**AGENDA  
TOWN OF PITTSFORD  
PLANNING BOARD  
AUGUST 12, 2024**

**Passero Associates, Pittsford Oaks Apartments**  
Preliminary/Final Subdivision and Preliminary Site Plan

Re: **Pittsford Oaks Apartments Comments letter dated 7/3/2024**  
**Preliminary Site Plan & Preliminary/Final Subdivision**

This letter is regarding the comments letter received from the DRC for the above project dated July 3, 2024. The comments are listed in the order received and our responses are in bold italics.

Drawing No. **C 103**

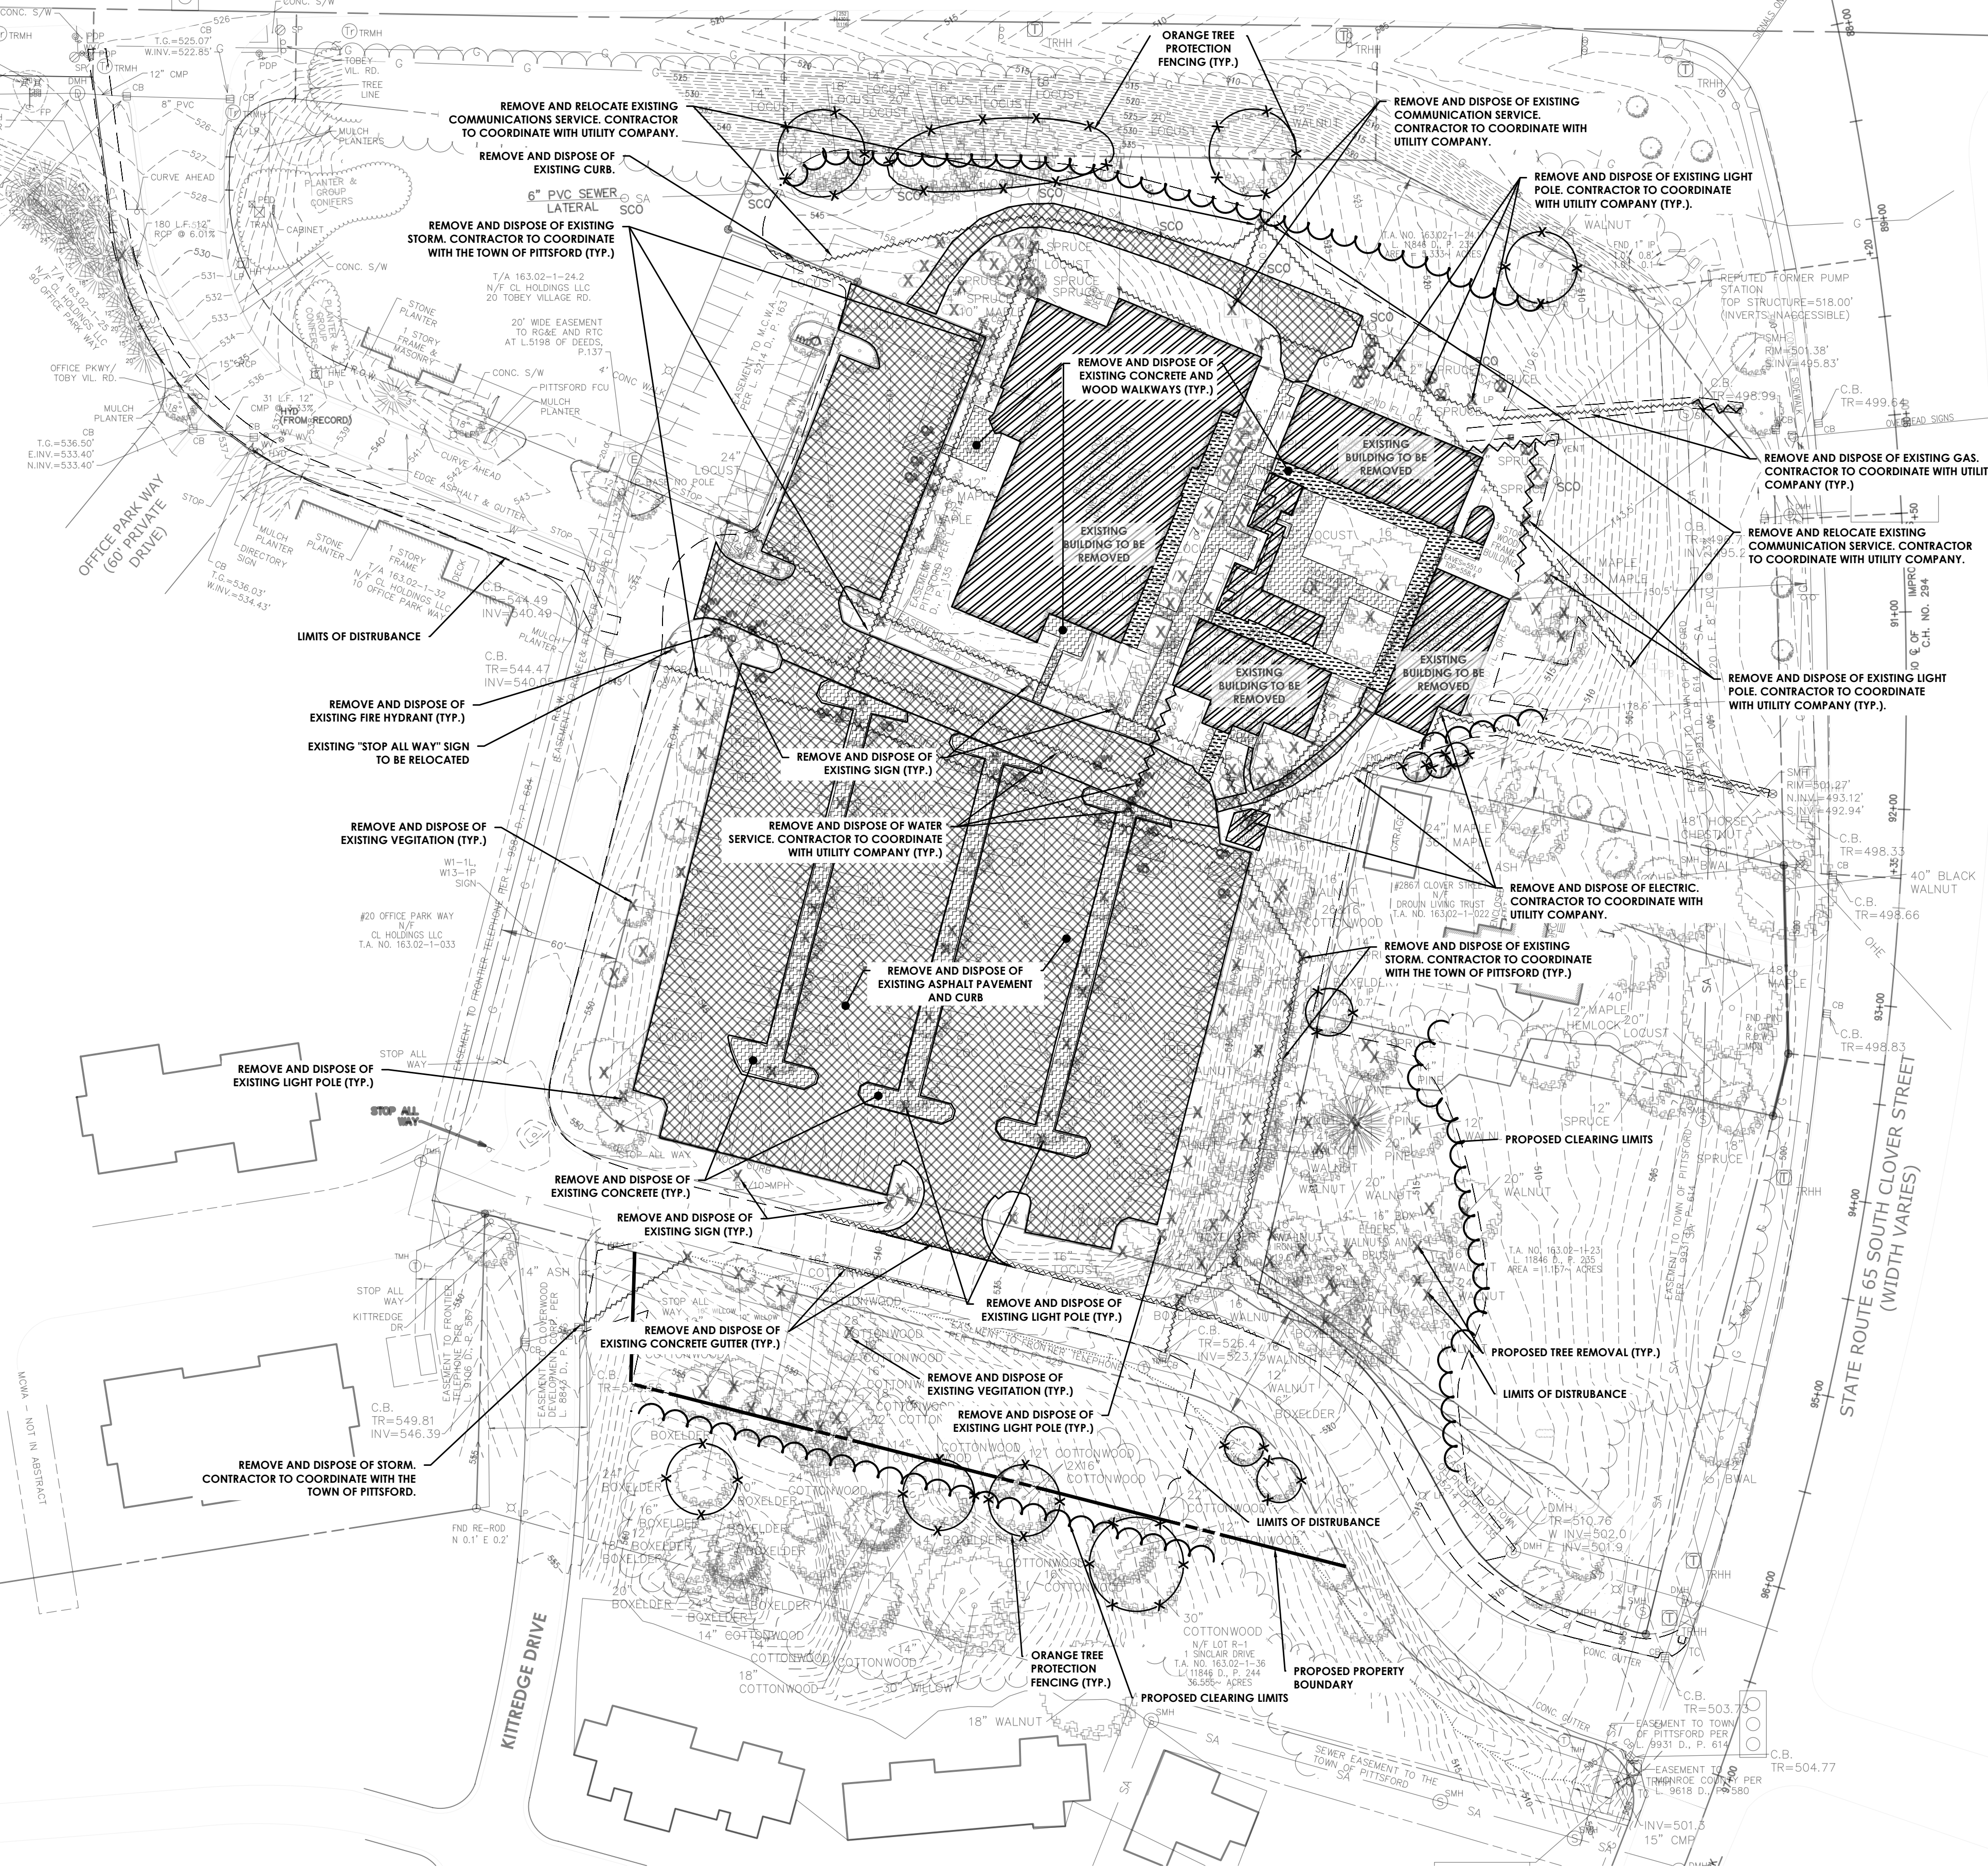
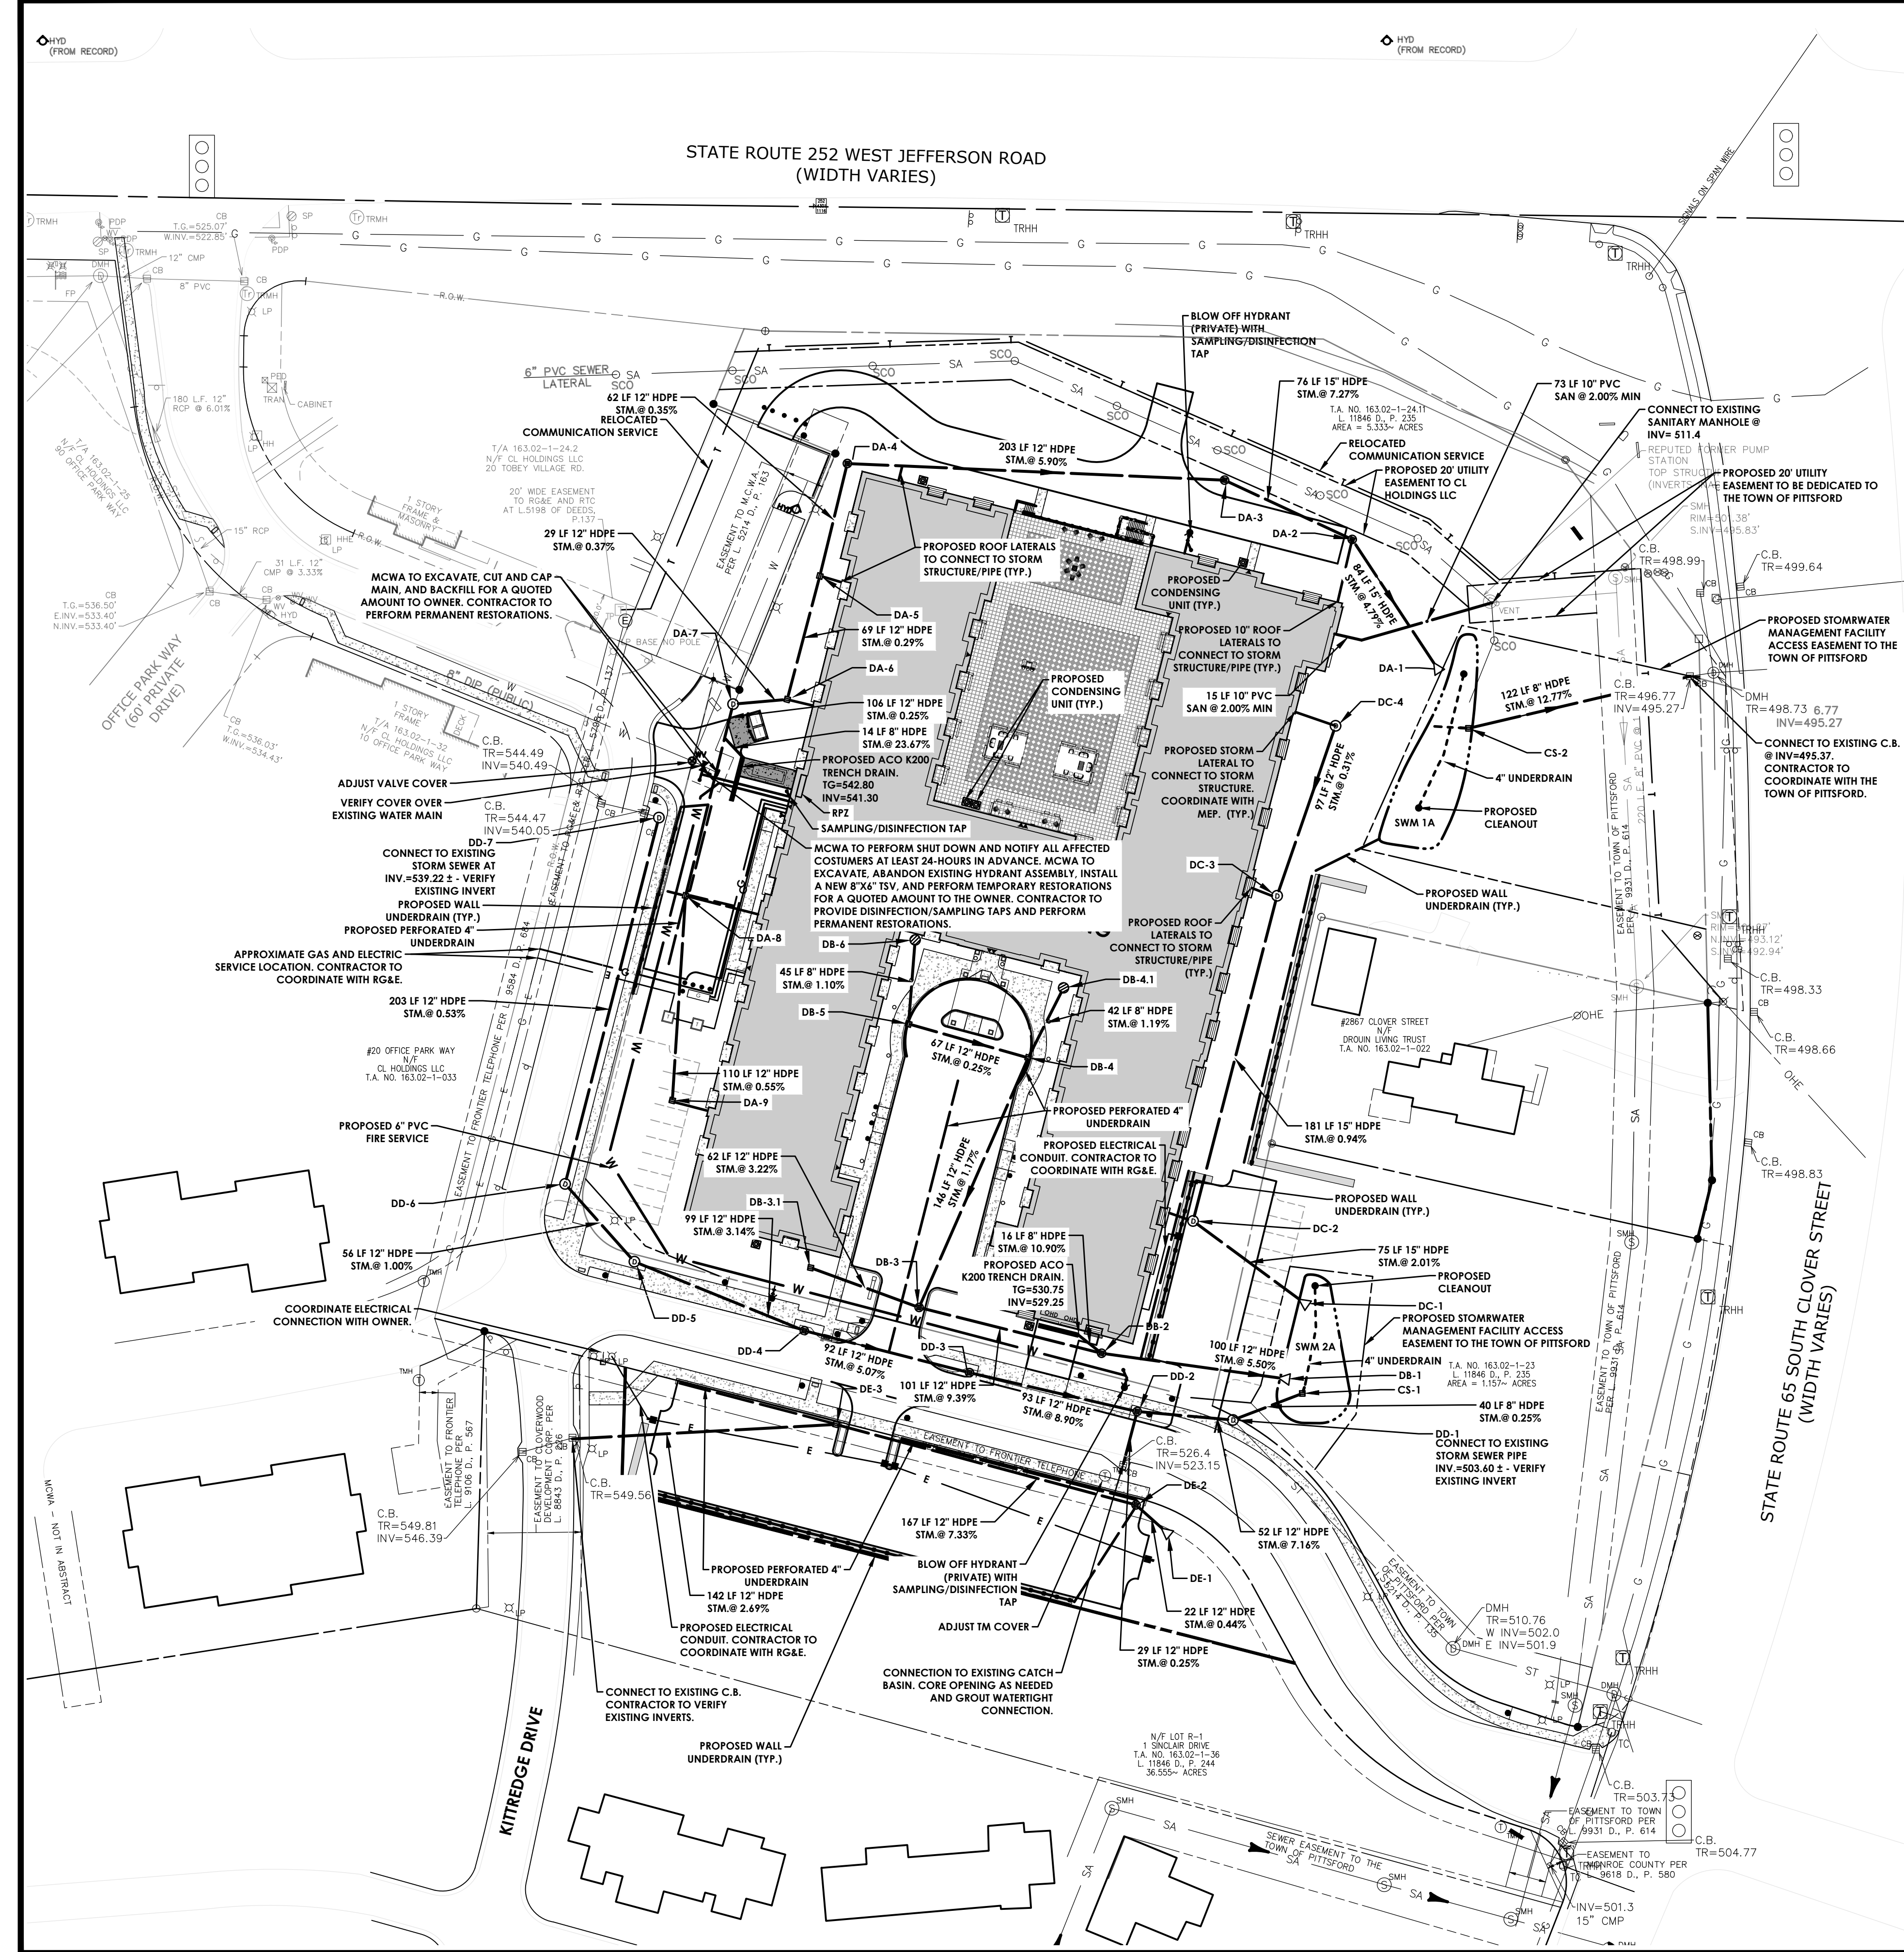
15. The demolition plan should include the detailed sequence of demolition notes. For example, provide the Town with Building/Demolition permit application and supplemental materials; call for utility stake outs; pre-construction meeting with the Town; fence the site; verification that utilities have been disconnected; flag clearing limits, provide tree protection; schedule site meeting with the town to confirm clearing limits and tree protection; hours of demolition; where material(s) will be taken; dust control measures; erosion control, etc. (DPW)

**Response: Acknowledged.**
17. Demolition sequencing notes should be provided as elimination of the storm sewer within the building footprint will be contingent on construction of the new sewer. (TE)

**Response: Clearing limits and trees to be removed have been clarified.**
24. The existing utility line types (electric, telephone, sewer, etc.) to be removed are difficult to read due to the heavy zig-zag lines. (TRE)

**Response: All known sanitary sewer laterals all shown on plans (three from the existing Barn Bazaar and one from PFCU).**
26. Please review the annotations on the demolition plan:

**Response: Acknowledged. Notes added to sheet C103 as requested.**
16. Demolition and construction work involving overly disruptive equipment shall be limited to weekdays from 7AM to 5PM to reduce noise impacts to adjacent neighborhoods. Variation from these days and or times will require DPW approval. (DPW)

**Response: Demolition notes added to sheet C103 as requested.**
18. Please add limits of disturbance to the demolition plan and on the site plan under the site data table. (DPW)
